DOCKET ITEM #8
Special Use Permit #2020-00065
765 John Carlyle Street and 1900 Eisenhower Avenue –
Carlyle Block P

Public Hearing and consideration of a request for a Special Use Permit Amendment to the Carlyle SUP to increase the gross square footage allowable in Block P (within the allowed maximum for the Carlyle District); to convert approved office/retail gross square footage to residential (Elderly Housing); to amend the Design Guidelines for Block P – including but not limited to an increase in height from 200' to 210'; and, to amend the Land Use Allocation Tables (amending SUP#2018-0039) (Carlyle Block P); zoned: CDD #1/Coordinated Development District #1.

SUP#2020-00065
765 John Carlyle Street and 1900 Eisenhower Avenue
Carlyle Block P Amendment

Illustration B: Height of Retail Canopies – Current Proposal

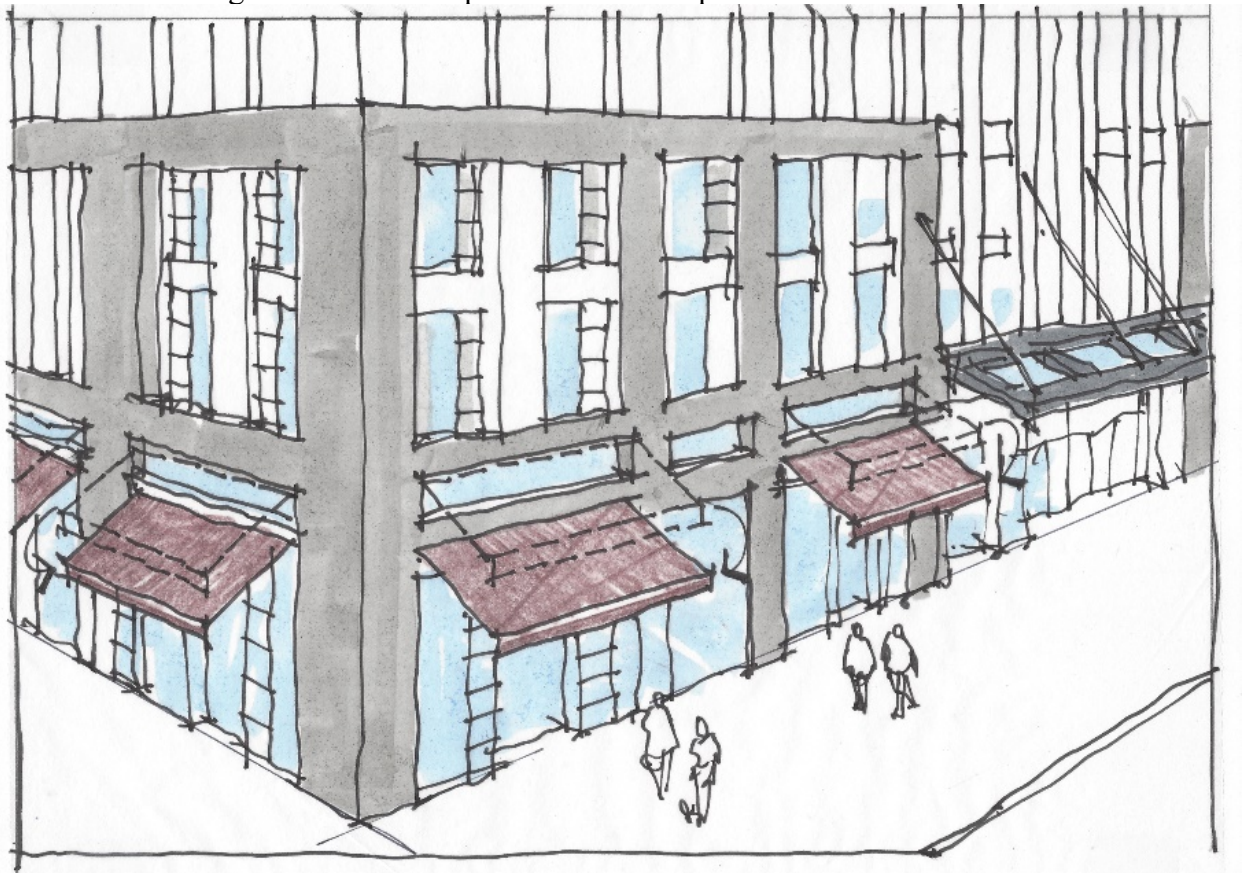
#22 The fabric awnings shown in the current design, while proposed to be fixed on stationary metal frames, still have the appearance of retractable ones in the rendering; further, they appear to be located very high relative to the pedestrian scale. In the interests of scale, weather protection, and opening up the views through the significant transom glass shown, staff suggests lowering the awnings to the next lower building element, a substantial horizontal that separates the storefront glass and transom. An added benefit of this adjustment would be to clearly show the hierarchy that separates these awnings from the metal and glass canopy at the main lobby entrance (Illustration B, below).

Illustration B: Height of Retail Canopies – Staff Proposed Adjustments

Illustration C: Approved Garage Screening at North Tower

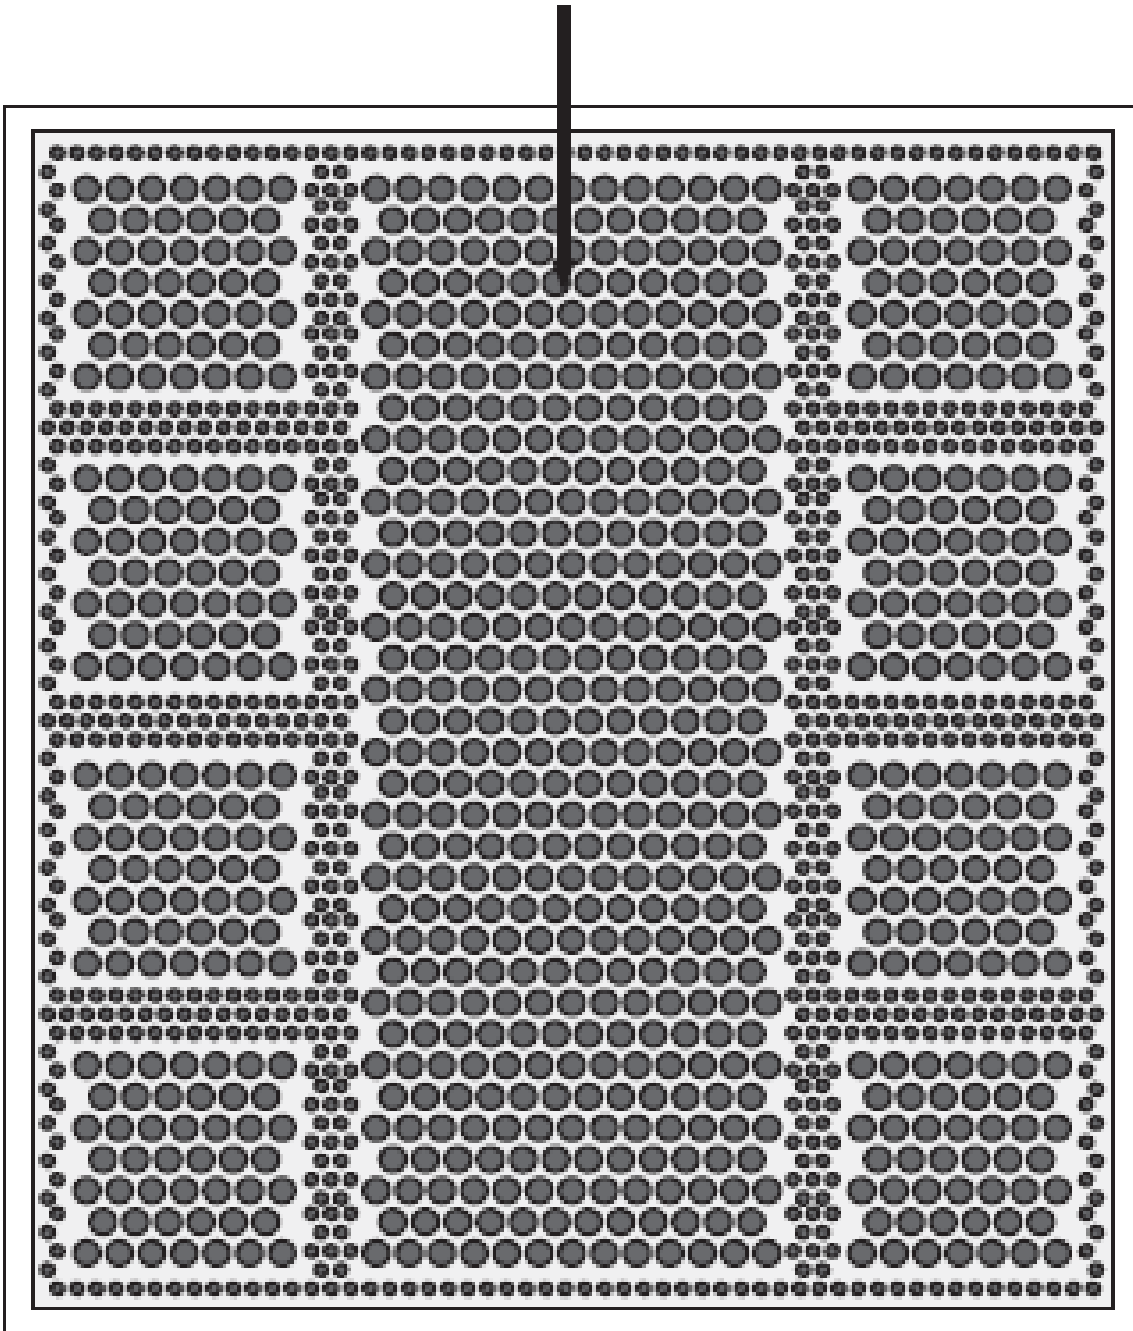
While the previous design was approved with above-grade, naturally-ventilated parking, the screening as approved (and as still proposed for the revised north tower) incorporated a richly-detailed combination of glass, custom louvers, and mullion framing that mitigated the visual impact of the parking (Illustration C, below). Staff does not support the current proposal for the parking screening of the south tower, which proposes to mimic the mullion pattern in the tower above through varying the density of perforations in a large surface of what appears to be flat, perforated metal (Illustration D, below).

Illustration D: Screening as Proposed

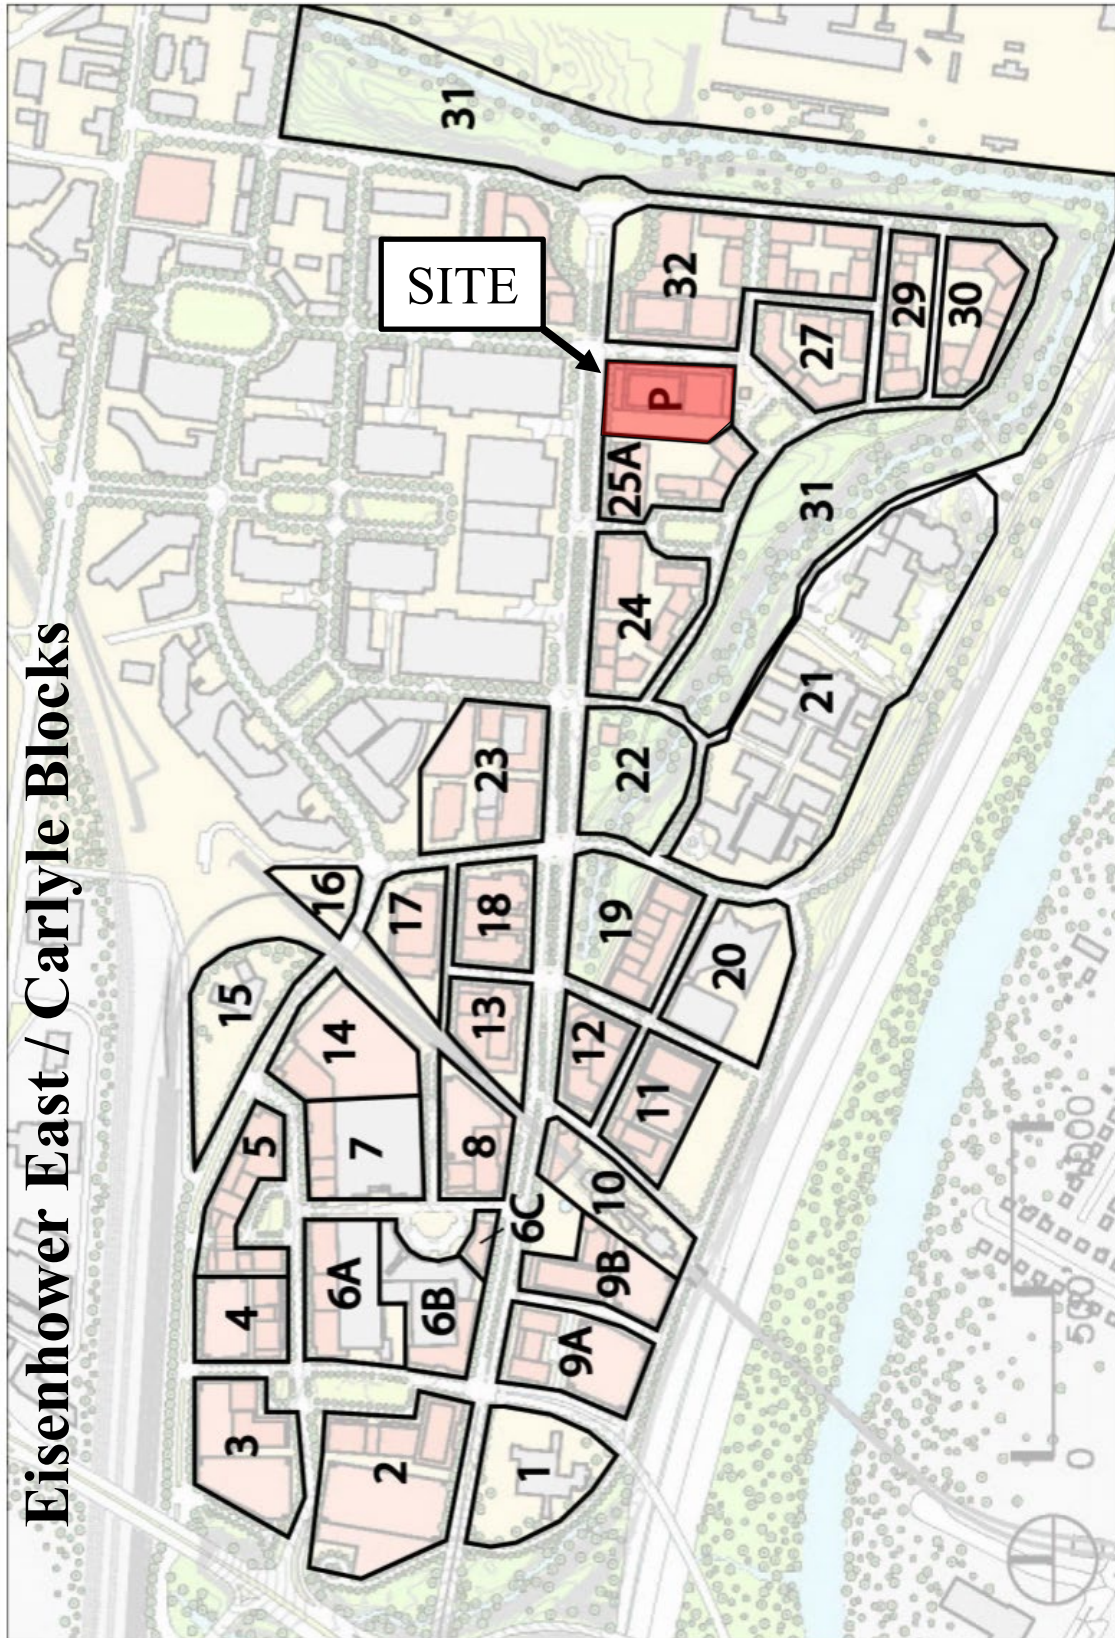
Staff does support the idea of carrying the subdivision pattern from the glazed openings above down into the parking levels, and differentiating the south tower screening from that in the north

tower, but requires a solution that incorporates a variety of depths, along with a variety of materials (preferably including glass) for some portions of the enclosure. A similar solution was proposed and approved by the DRB for the above-grade parking levels of the WMATA Virginia Headquarters building, currently under construction along Mill Road in Eisenhower East. As in the case of the North Tower, elements of the occupied floors enclosure system above are carried down through and incorporated into, the parking screening system (Illustration E, below).

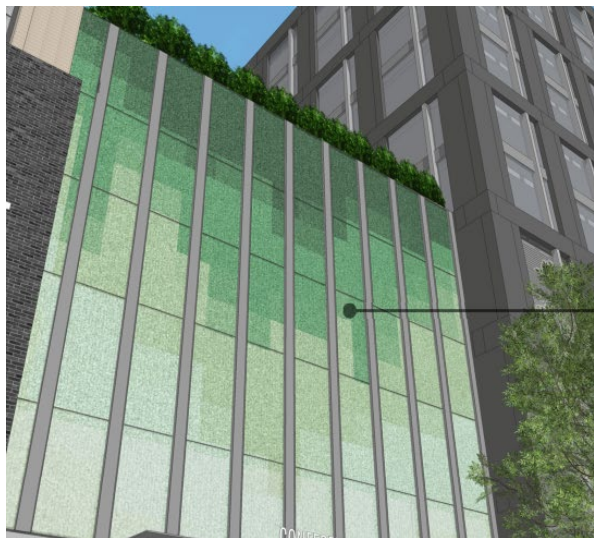
Site constraints and previous approvals dictate that parking ascend above grade on Block P. Never the less, the proposed office tower will be full story shorter than the original approval, as the applicant has removed one (1) level of structured parking, as intimated above. Generally speaking, the screening at the podium level, P2 – P5, is bifurcated into either glazing, or metal systems. More specifically, glazing is used to conceal the first two levels to the parking, which is setback slightly from the retail base in plan, from the retail level,

while the remaining upper floors (P4 – P5) are concealed by a perforated metal panel, similar to the approve design for the south tower. This design uses various systems of aluminum/steel to recall the typical expression of a window. However, as intimated, the accompanying detail requires reconciliation.

D. Podium/Base

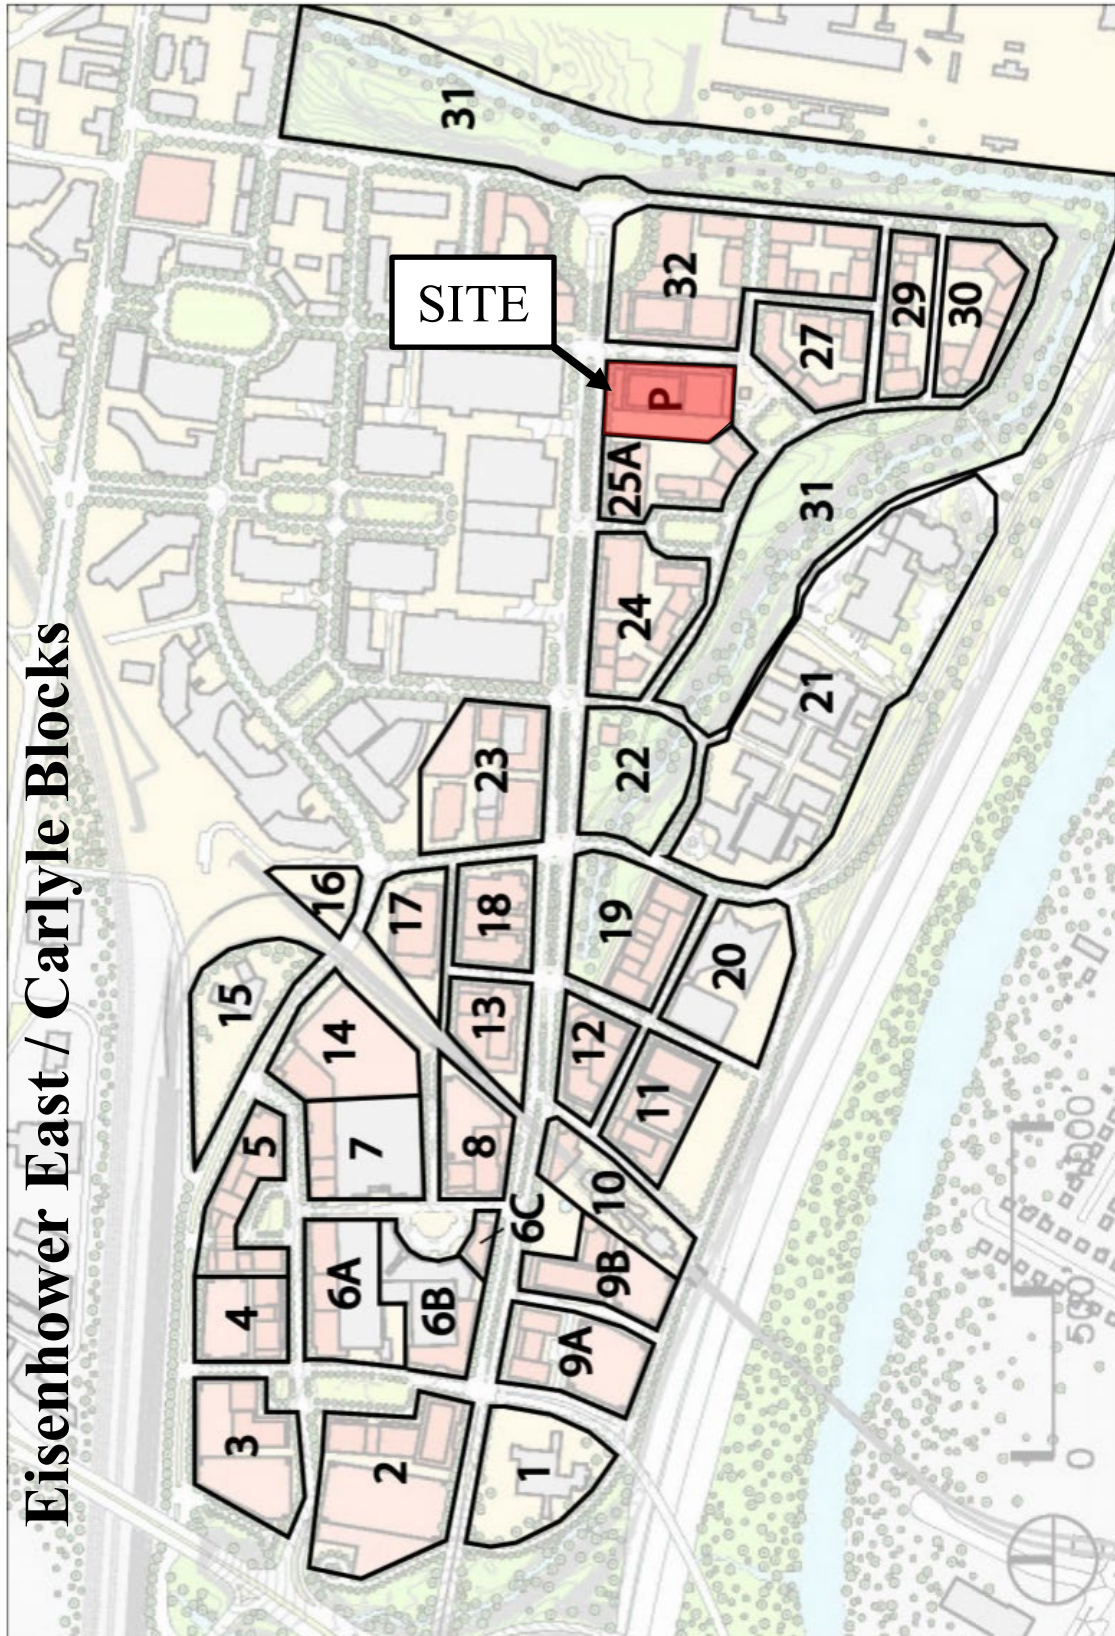
The podium level of block P, which is being pursued under this final submission, is a 5-level retail and parking structure that anchors both the north and south towers. Generally speaking, staff are in agreement with the general architecture and expression, however as intimated previously and in the South Tower's report, the use of the dark brick to create a strong, readable base, is not successfully integrated into the overall architecture. The brick base should be used at

the human scale (1st floor only) level to create enough contrast with the materiality of same above, while still reading as a strong, base-defining architectural element.
